613 WILLS FOREST RD
GLENWOOD-BROOKLYN
HISTORIC DISTRICT (R-10)

APPLICATION FOR A CERTIFICATE OF APPROPRIATENESS – STAFF REPORT

079-18-CA 613 WILLS FOREST STREET
Applicant: DAVID COLE FOR INCLUSION STUDIO PLLC
Received: 6/12/2018 Meeting Date(s):
Submission date + 90 days: 9/10/2018 1) 6/28/2018 2) 8/23/2018

Nature of Project: Addition of full 2nd story to existing 1 ½-story rear addition; roof alteration to rear of historic pyramidal roof

2 PR ROOF PLAN
SCALE: 1/8" = 1'-0"

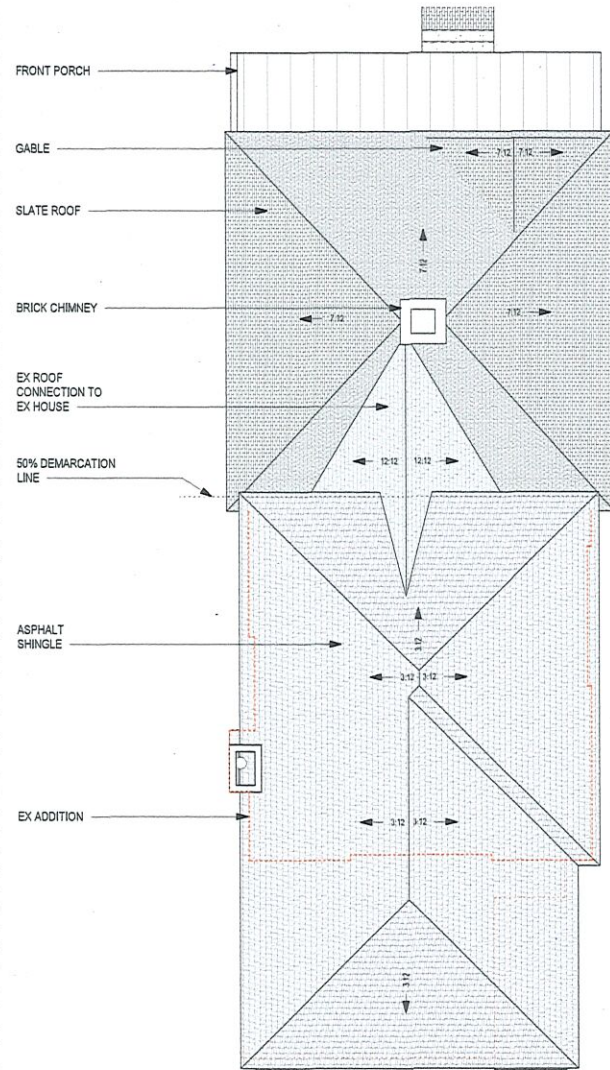
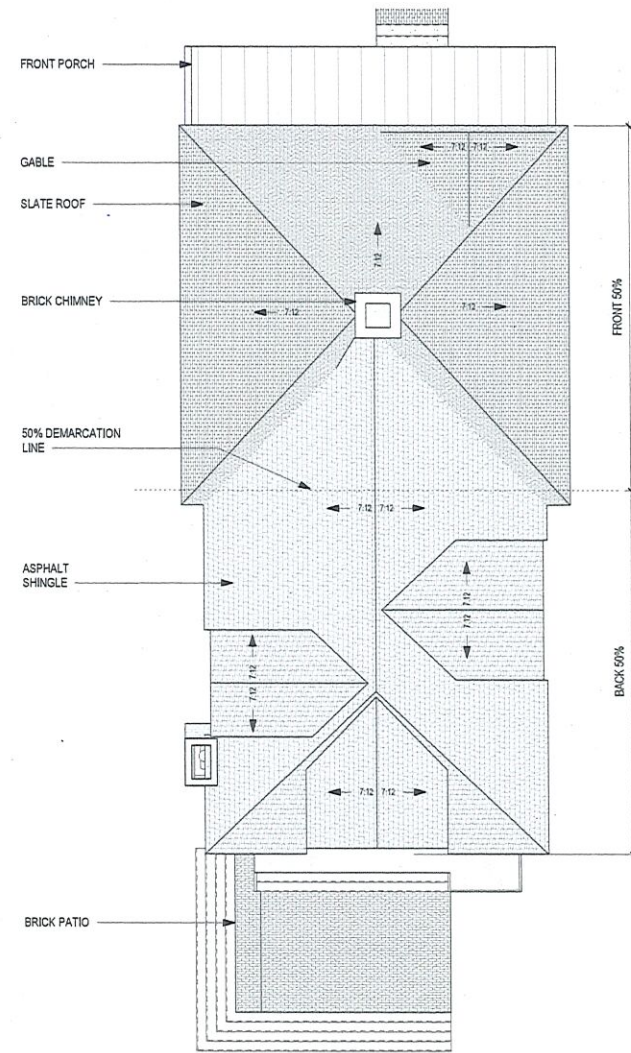
7. Please provide roof plans for both existing and proposed.
These have been provided on A-103.
8. It appears the proposal includes removing the front gable. Is this accurate? It does not get removed.
The existing gable is to remain and this has been clarified on the proposed street elevation.

1 PR STREET ELEVATION
SCALE: 3/16" = 1'-0"

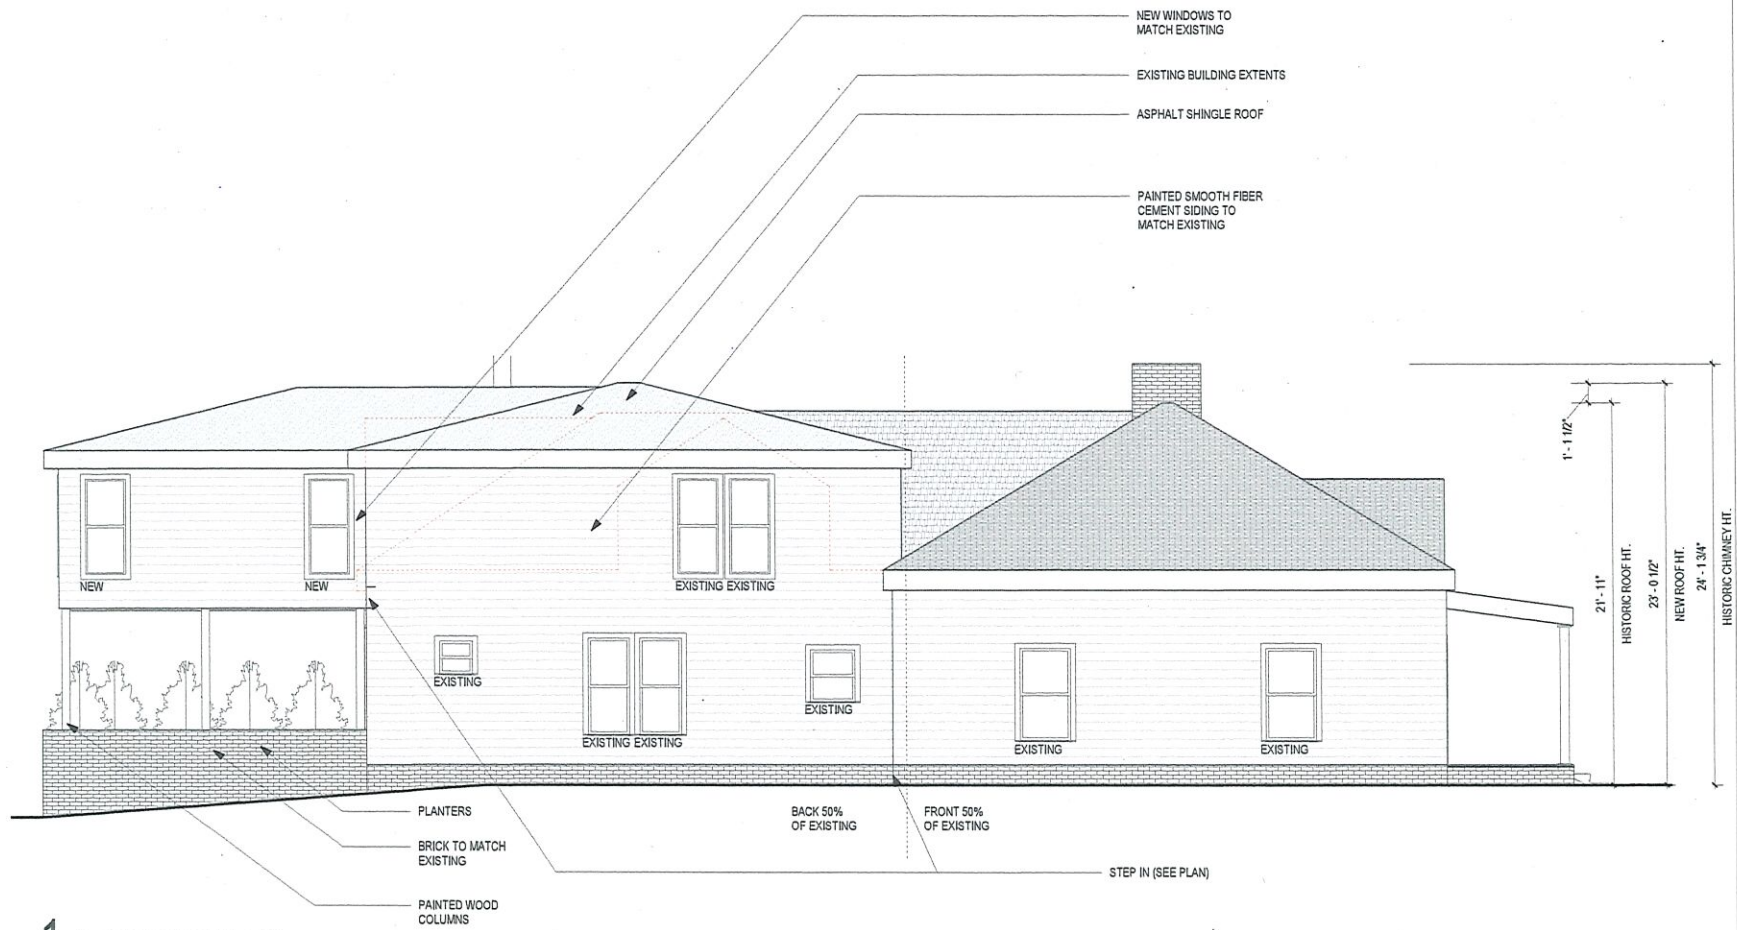
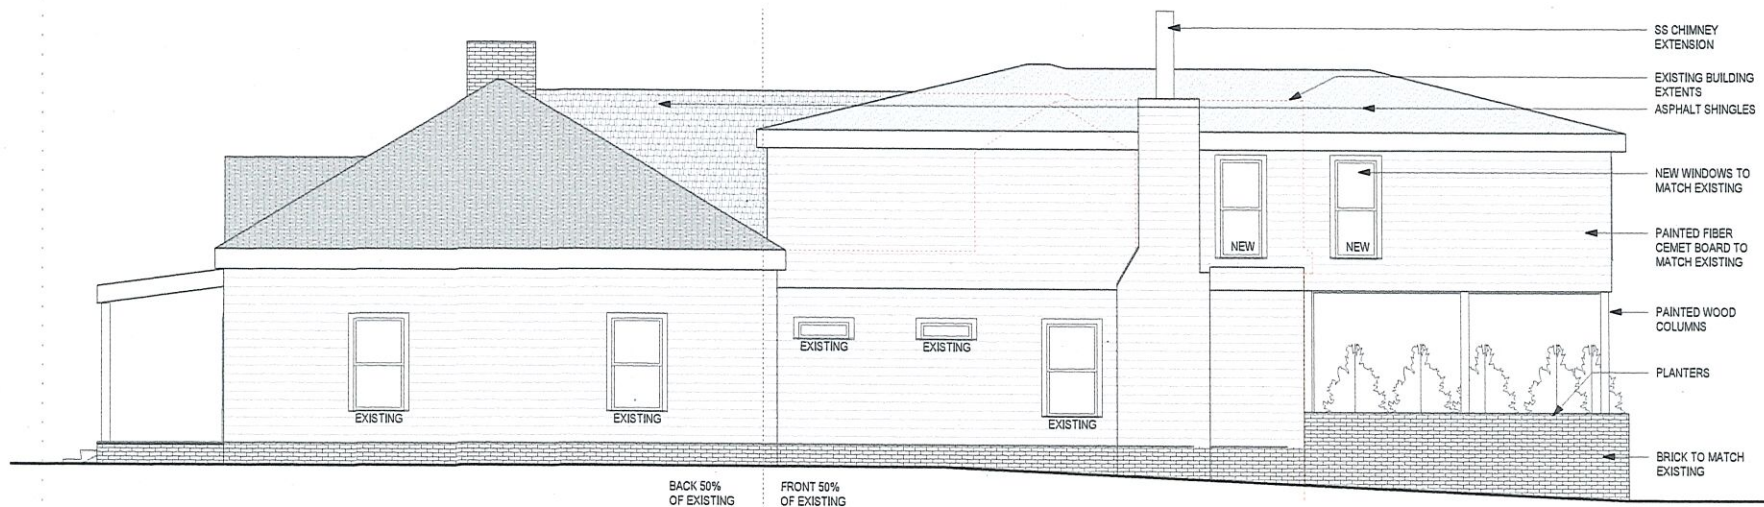
1. The proposed addition is at the rear of the house, and changes the existing 1 ½-story addition into a 2-story addition by raising and changing the roof form and by extending the walls to full height. The existing addition measures 22' at the roof ridge. The drawings show an increased roof ridge height, but do not clearly convey the measurement of the roof ridge height. **The drawings have been revised to more clearly indicate the roof heights.**

2. Drawings seem to indicate the proposal brings the west wall of the addition out to meet the wall plane of the historic house, rather than being inset as it is currently. The chimney on the west elevation of the existing addition appears to be encased with a wall, rather than being outside of the west wall plane. **The design has been revised to keep the addition in line with the most recent addition and to step the addition to match the step from a previous addition.**

3. The side elevation drawings do not accurately portray the revised connection between the addition and the historic pyramidal roof. The drawings appear to show the roof ridge as a single line, but without the hatching underneath it to represent the roofing material this revised roof does not read as a solid roof plane in the way the other roofing is presented in the drawings. **The drawings have been revised to more clearly show the connection between the existing house and the addition.**
